1 GREENLINE REVISION 8/25/08
TEDD APPROVAL Jennifer Biddle
2 GREENLINE REVISION 9/18/08
TEDD APPROVAL Jennifer Biddle

MD 198 (TALBOT AVE) AND 8TH ST
LAUREL, MARYLAND

TRAFFIC SIGNAL PLAN

TS NO. 4663 | DRAWING NO. 1 OF 2 | SHEET NO. OF

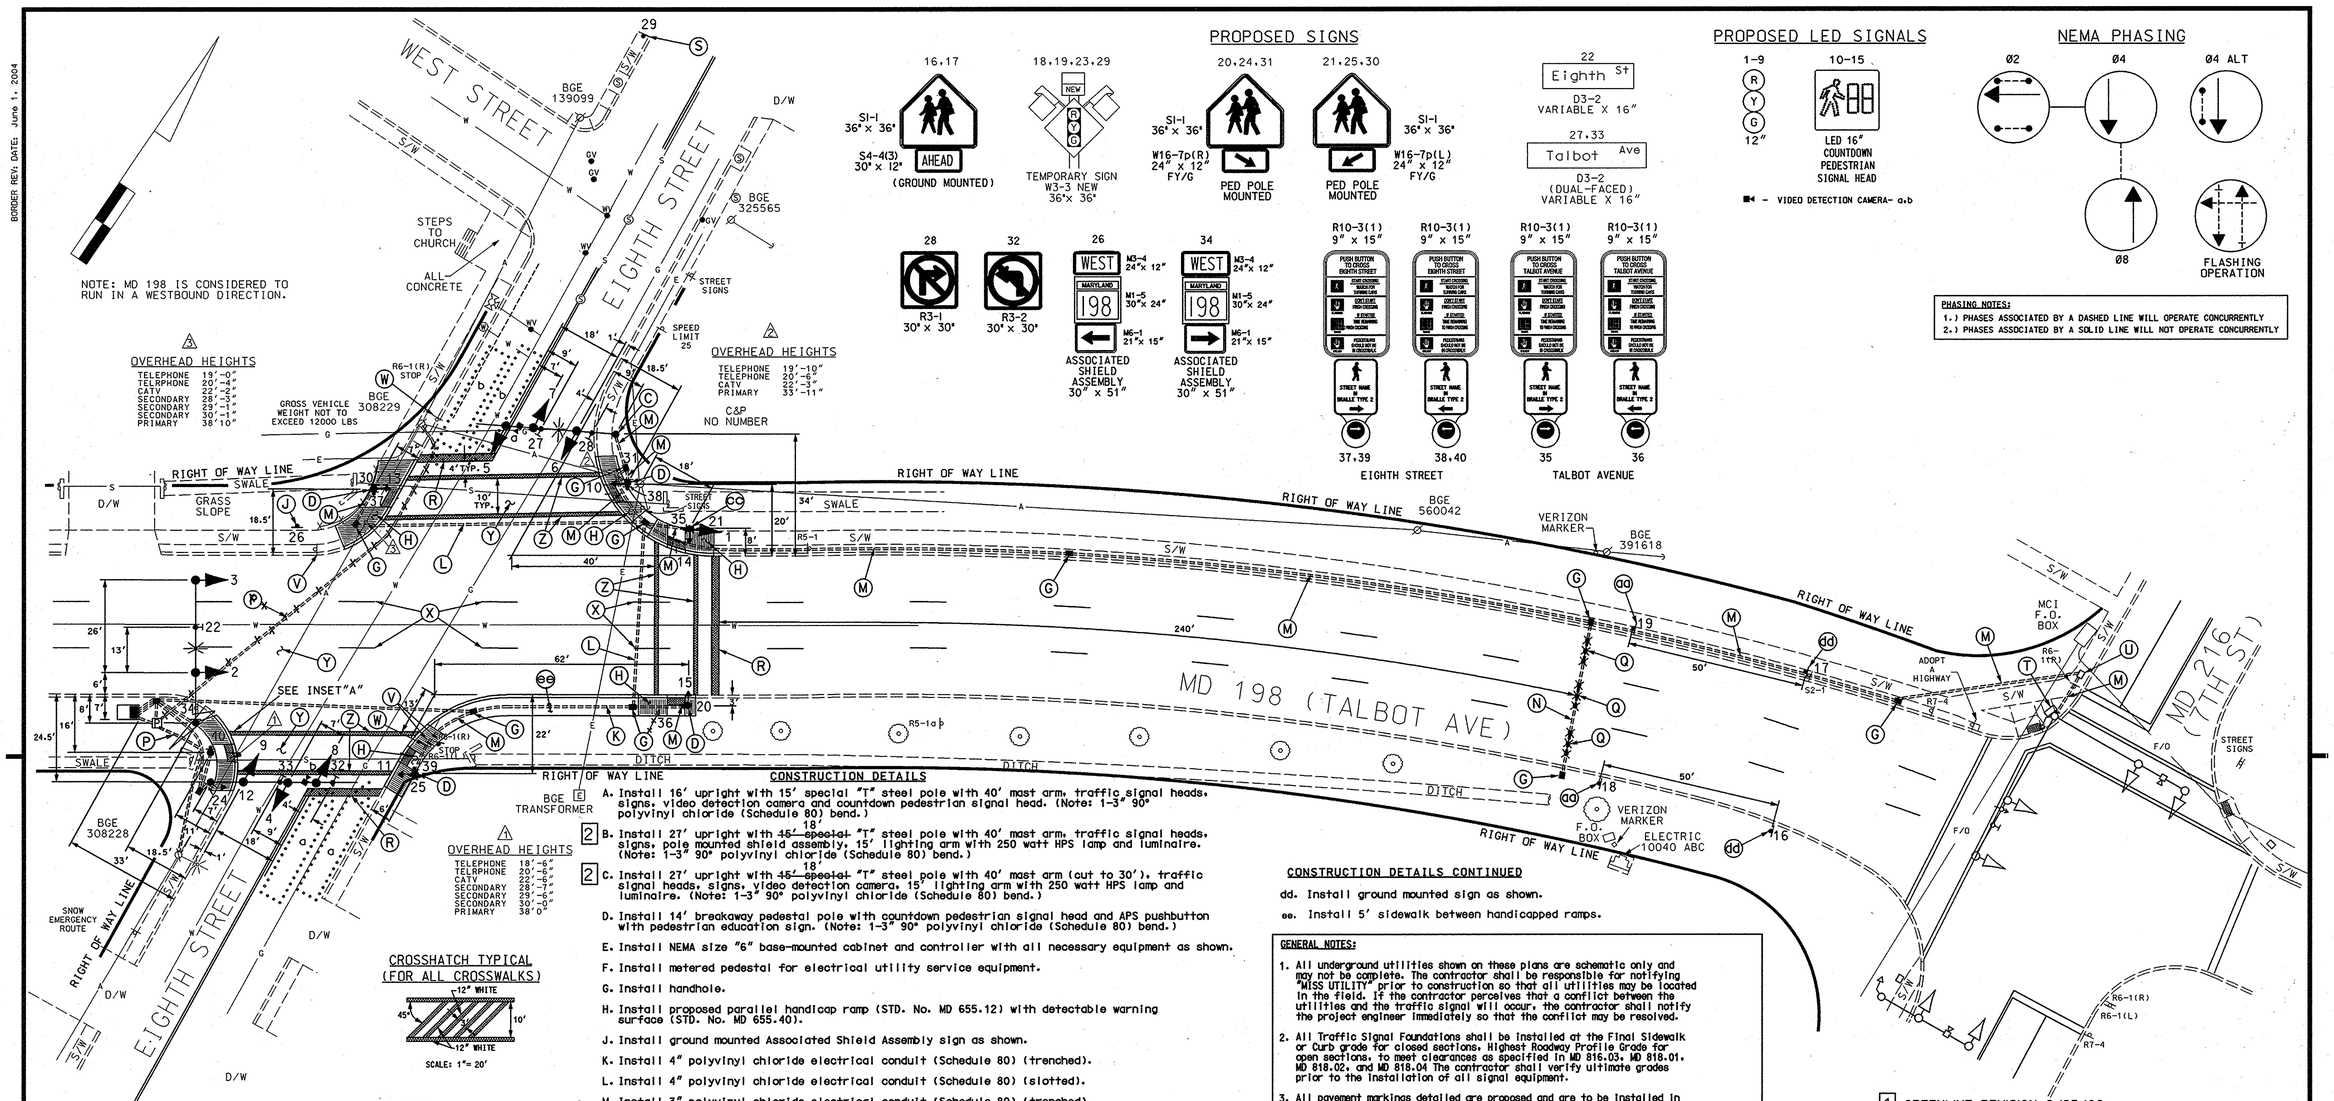
2 B. Install 27' upright with ~~45' special~~ 18' "T" steel pole with 40' mast arm, traffic signal heads, signs, pole mounted shield assembly, 15' lighting arm with 250 watt HPS lamp and luminaire. (Note: 1-3" 90° polyvinyl chloride (Schedule 80) bend.)

2 C. Install 27' upright with ~~45' special~~ 18' "T" steel pole with 40' mast arm (cut to 30'), traffic signal heads, signs, video detection camera, 15' lighting arm with 250 watt HPS lamp and luminaire. (Note: 1-3" 90° polyvinyl chloride (Schedule 80) bend.)
